SERVICE No. 991A BULLETIN

DATE: January 29, 1996

(Service Bulletin No. 991A supercedes and voids Service Bulletin No. 991 dated January 10, 1996)

**Replacement or Modification of the
Alternator Out Light Fuse**

**PA-28-161 (CADET)**
(Refer to the Maintenance Manual as necessary.)

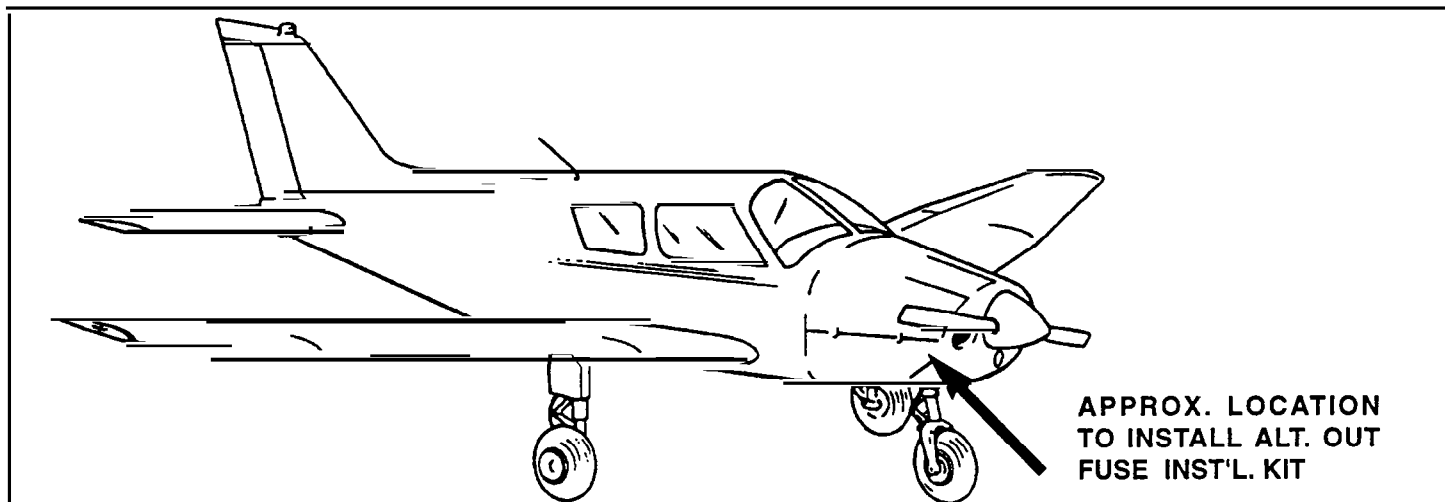
1. Remove the engine cowlings.
2. Locate the alternator AUX terminal.
3. Remove the existing wire from the alternator AUX terminal and install the Alt Out Fuse Installation Kit Piper Part Number 766-293 per kit instruction.
4. Secure the fuse holder with a Ty-rap.
5. Perform run up and functional check.
6. Reinstall the engine cowlings.

**PA-28R-201 (ARROW)
PA-28R-201T (TURBO ARROW)**

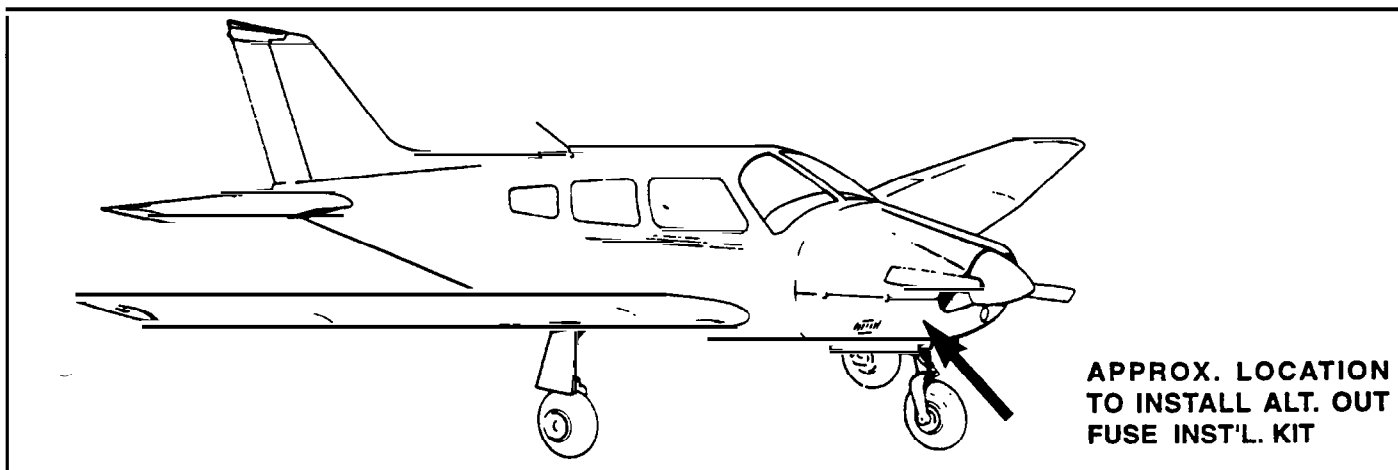
1. Remove the engine cowling. (Arrow shown as typical.)
2. Locate the alternator AUX terminal.
3. Remove the existing wire from the alternator AUX terminal and install the Alt Out Fuse Installation Kit Piper Part Number 766-293 per kit instruction.
4. Secure the fuse holder with a Ty-rap.
5. Perform run up and functional check.
6. Reinstall the engine cowling.

PA-38-112 (TOMAHAWK)

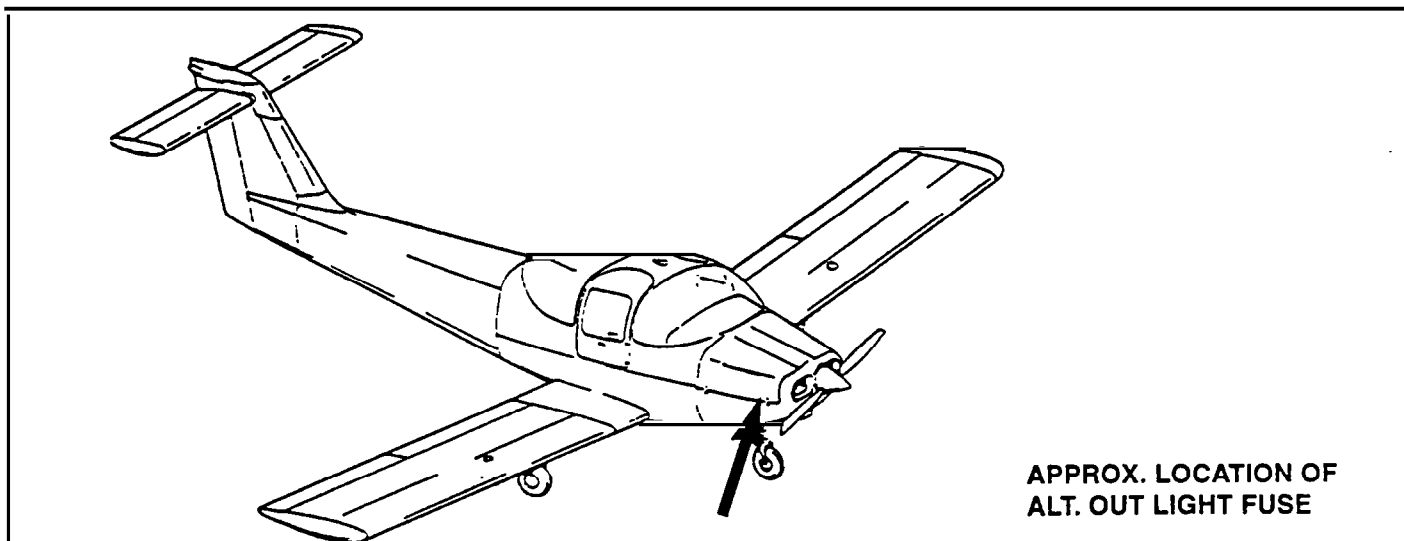
1. Remove the engine cowling to gain access to the alternator.
2. Locate the alternator AUX terminal and follow the wiring to the fuse holder between wire (WIC20) and (WID20).
3. Remove the existing fuse and install new fuse part number 461-643. *NOTE: Inspect condition of the existing fuse holder and replace as required.*
4. Perform run-up and functional check.
5. Reinstall the cowlings.

**PA-31, 31-325 (NAVAJO, NAVAJO C/R)
PA-31-350 (CHIEFTAIN & T1020)
PA-31P (PRESSURIZED NAVAJO)**

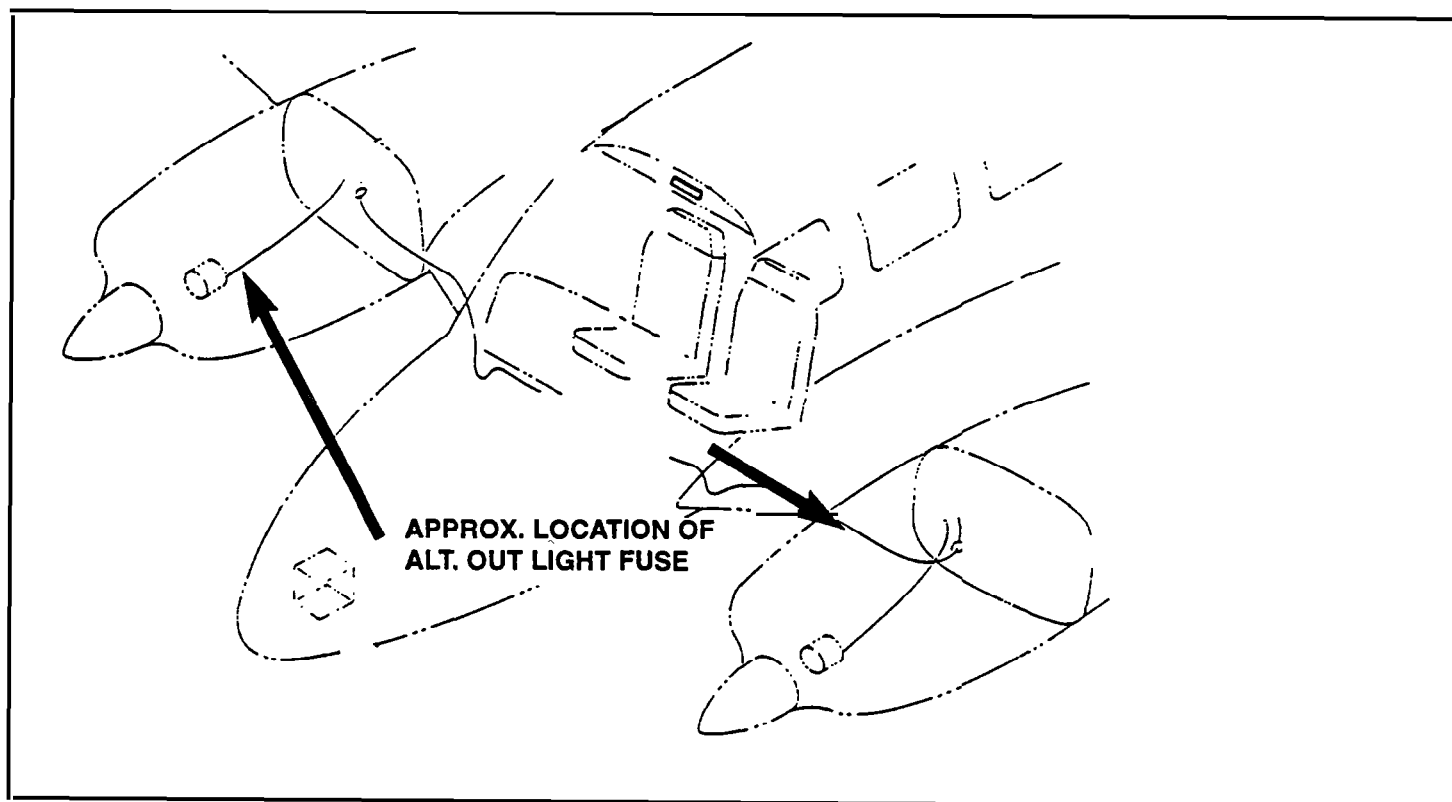
1. Remove the upper and lower engine cowlings to gain access to the alternators.
2. Locate the alternator AUX wire on the left and the right alternator.
3. Follow the wire to the fuse holder.
4. Remove the existing fuse and install fuse part number 461-643, secure wires and fuse holders after installation. *NOTE: Inspect condition of the existing fuse holder and replace as required.*
5. Perform run-up and functional check.
6. Reinstall the cowlings.
